ADDENDUM TO BID DOCUMENTS

Ventura Unified School District

ATLAS Classrooms 2 and 3 Conversion:

Addendum 1
DATE: March 28, 2022

AS-1.0

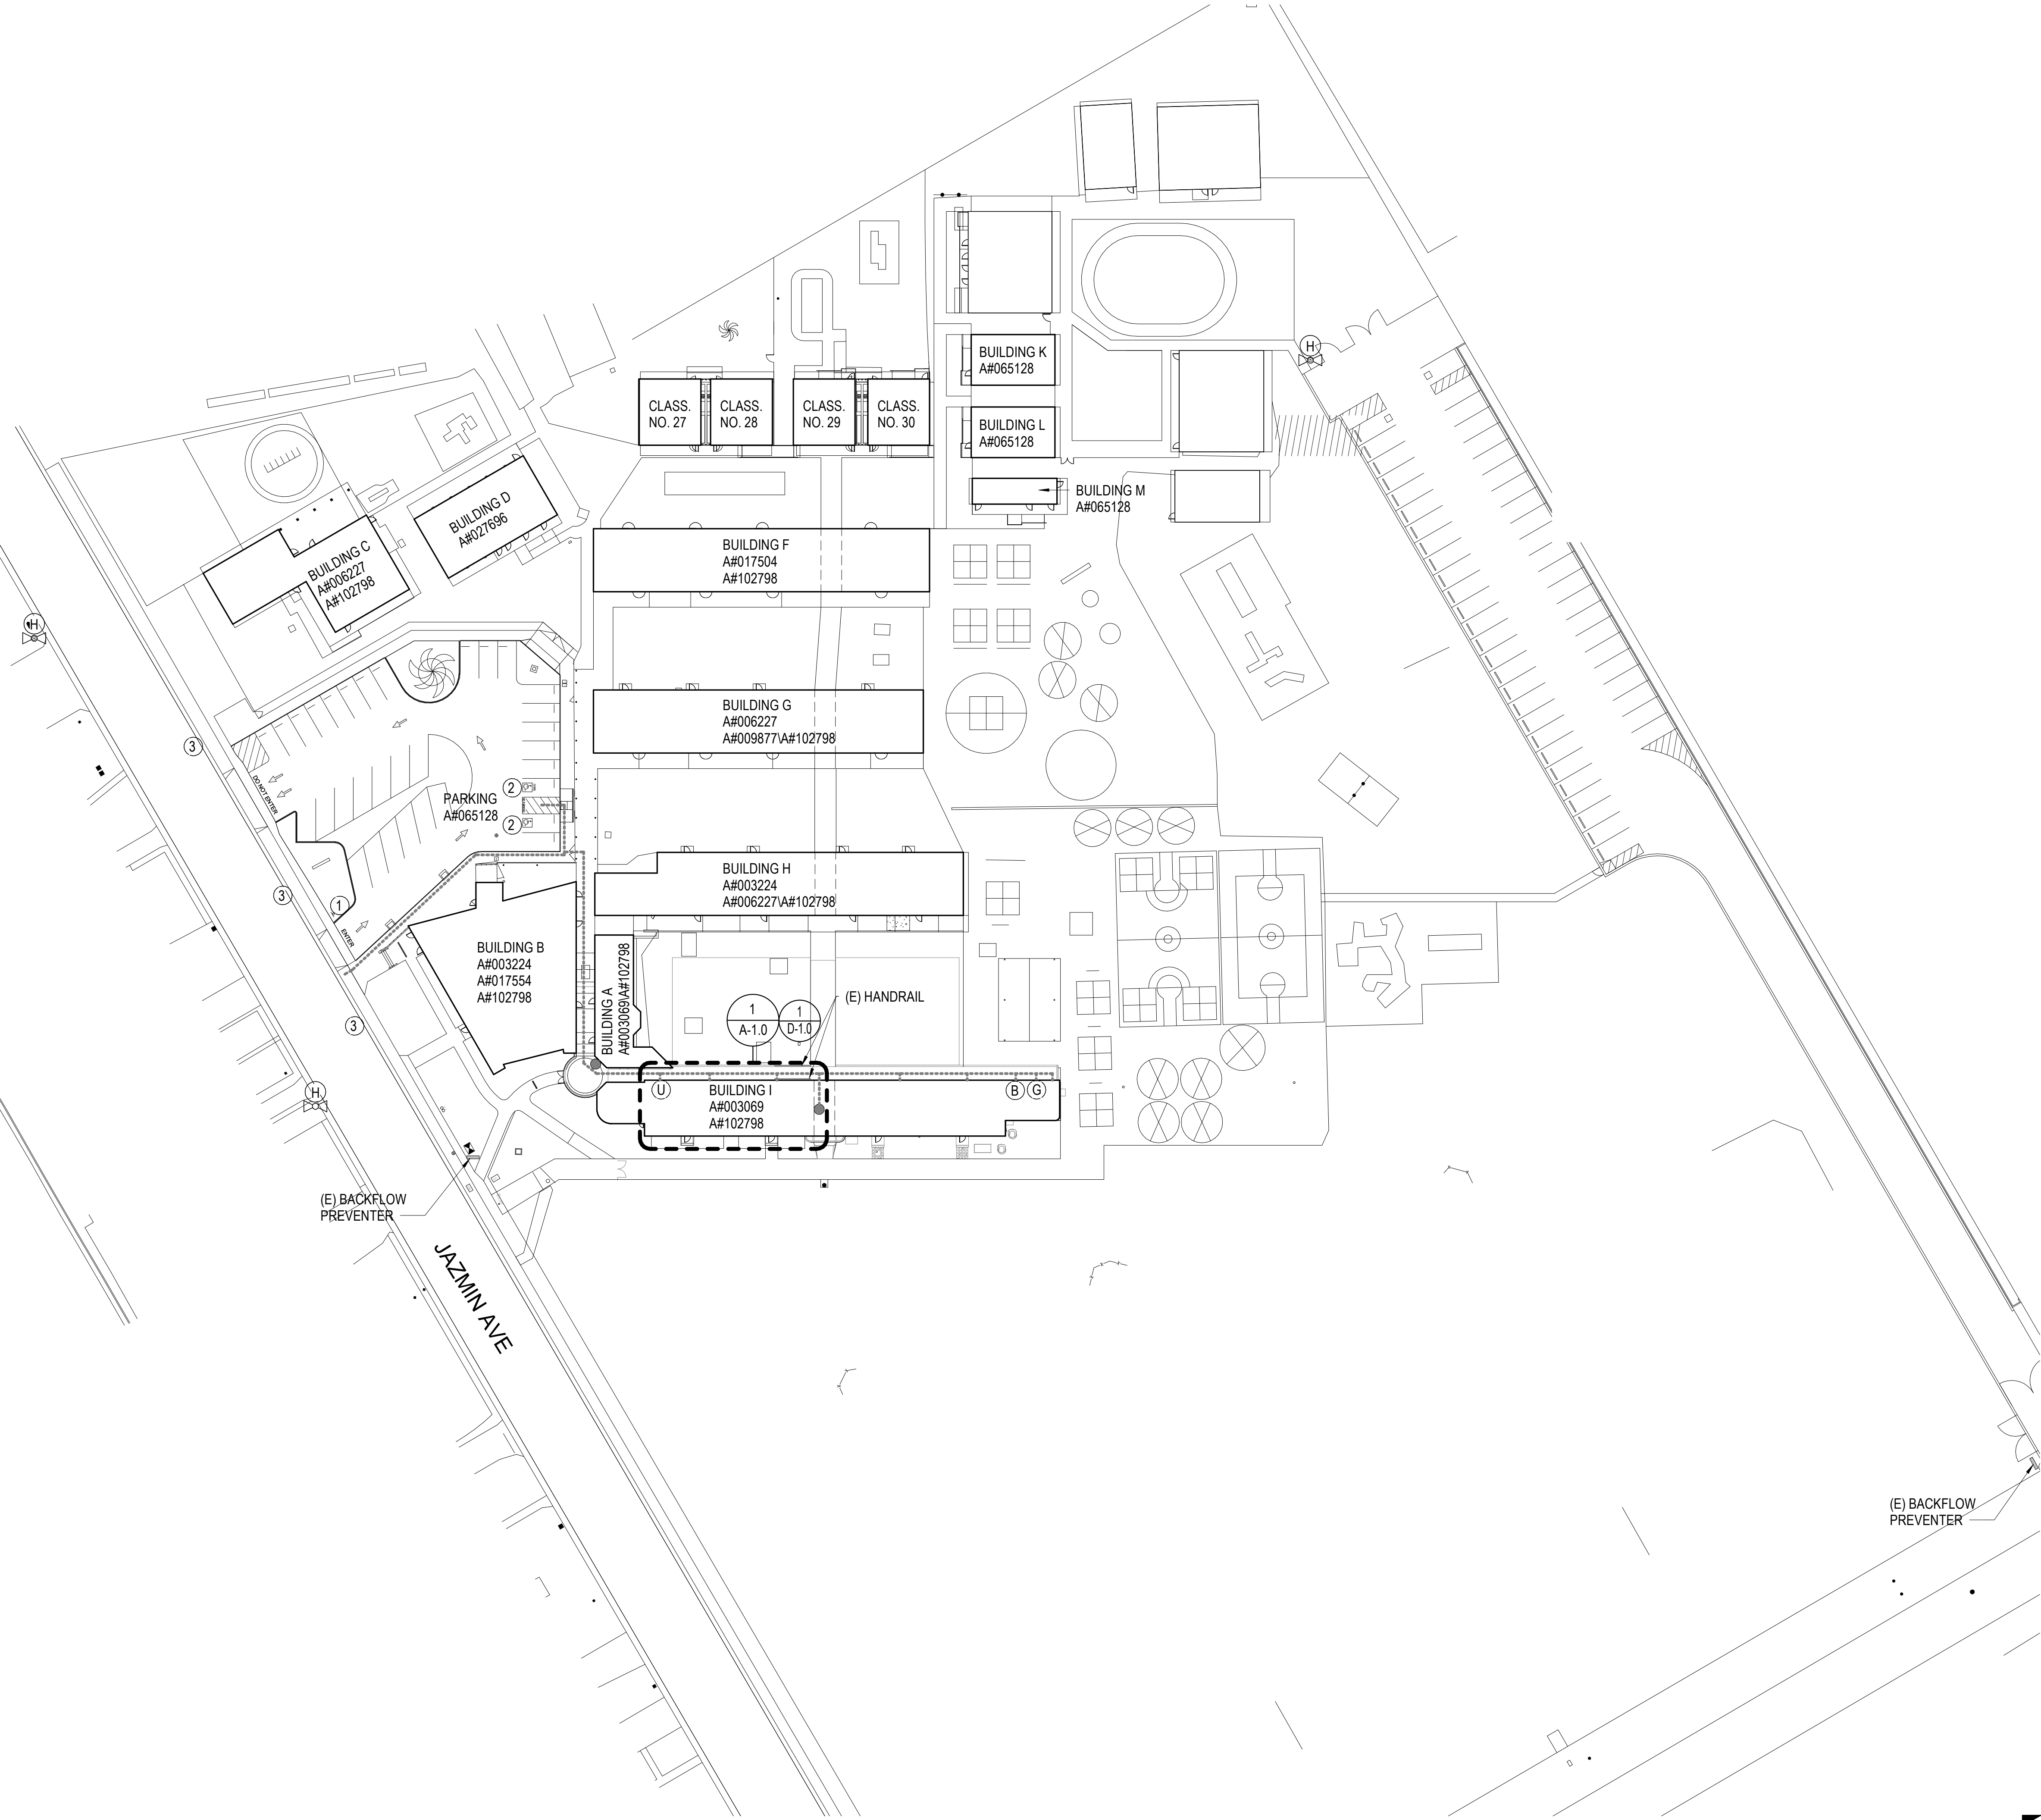
Item 2: Sheet AS-1.0 SITE PLAN

- Revised legend for boys' and girls' toilet rooms to be existing.

Question:

AS-1.0 - Please confirm accessible boys and girls toilet rooms are existing and not new per general note 2.

Answer:

Accessible boys and girls toilet rooms are existing and will not be requiring any new work. Legend has been revised on sheet AS-101.
